COMPARISON

COMPARISON - "I-WALLS"

STA 604+00

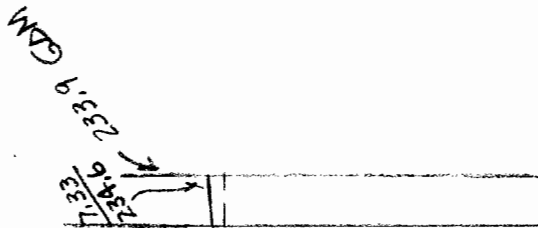
*3 sheetpile shifted 1.7' to Landside at critical sta 604+00. Checked GDM Section at 604+00 "NEED FILL at Levee Toe" STA 600+00 is OK for GDM Section. GDM Landside Stability Plate will have following Note "At STA 60+00 to Sta 6 (VACANT LOTS) A 30' berm 6 inches high from the landside levee toe will be needed."

M32MA → STA 604+00 GDM
M32MB → STA 600+00 GDM
LANDSIDE STAB.
